ISC-C1 Rack

Title		
ISC System Wiring Diagram		
Size	Number	Revision
B	D1900511	V11
Date:	8/28/2024	Sheet of 1 39
File:	C:\Users\...ISC_C1_SH1.SchDoc	Drawn By: Filiberto Clara

Title		
Squeezer RF Distribution		
Size	Number	Revision
C	D1900511	V11
Date:	8/28/2024	Sheet of 33 39
File:	C:\Users\...SqueezerRfDistribution.SchDpDrawn By: R. Abbott

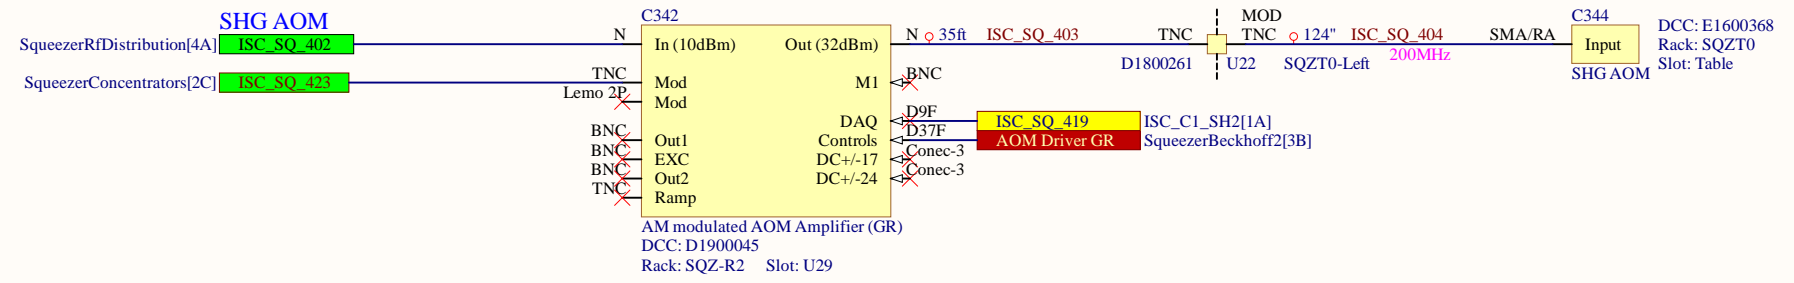
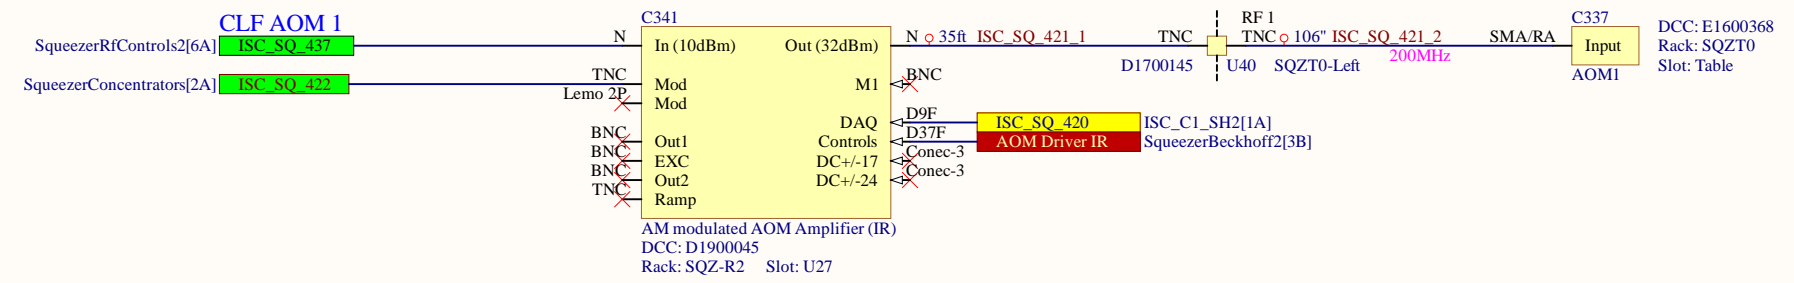
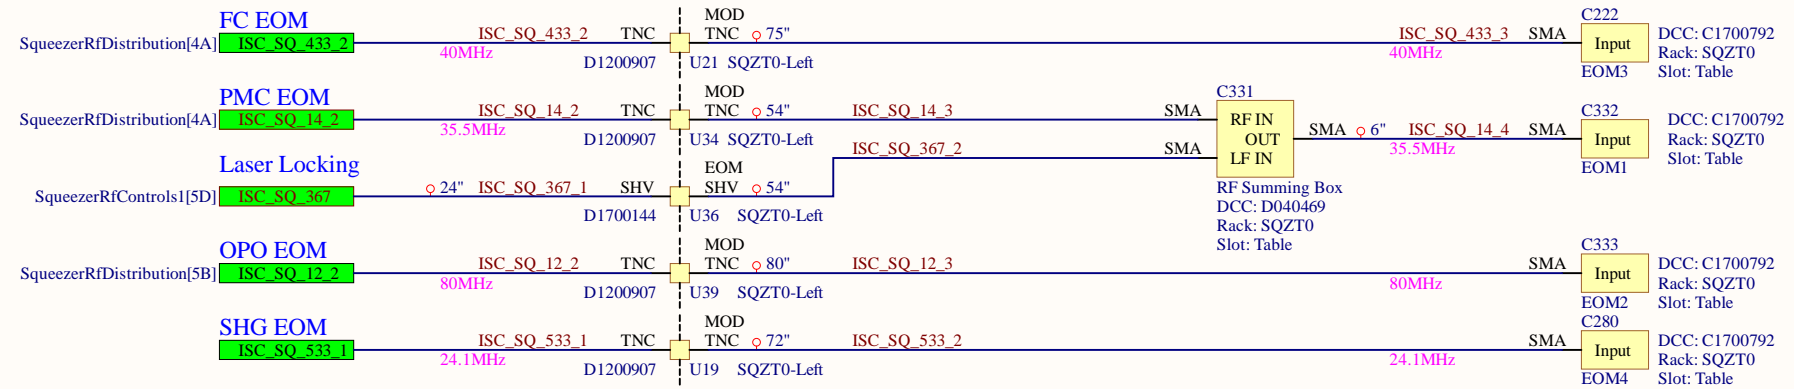
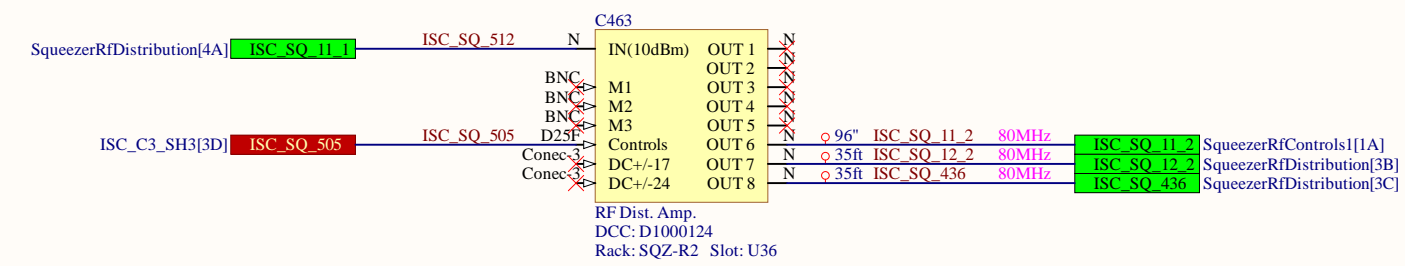
New cables for A_ start at ISC_SQ_430

RF cables carrying the AOM signals need to be 1/4" superflexible helical corrugated coax.
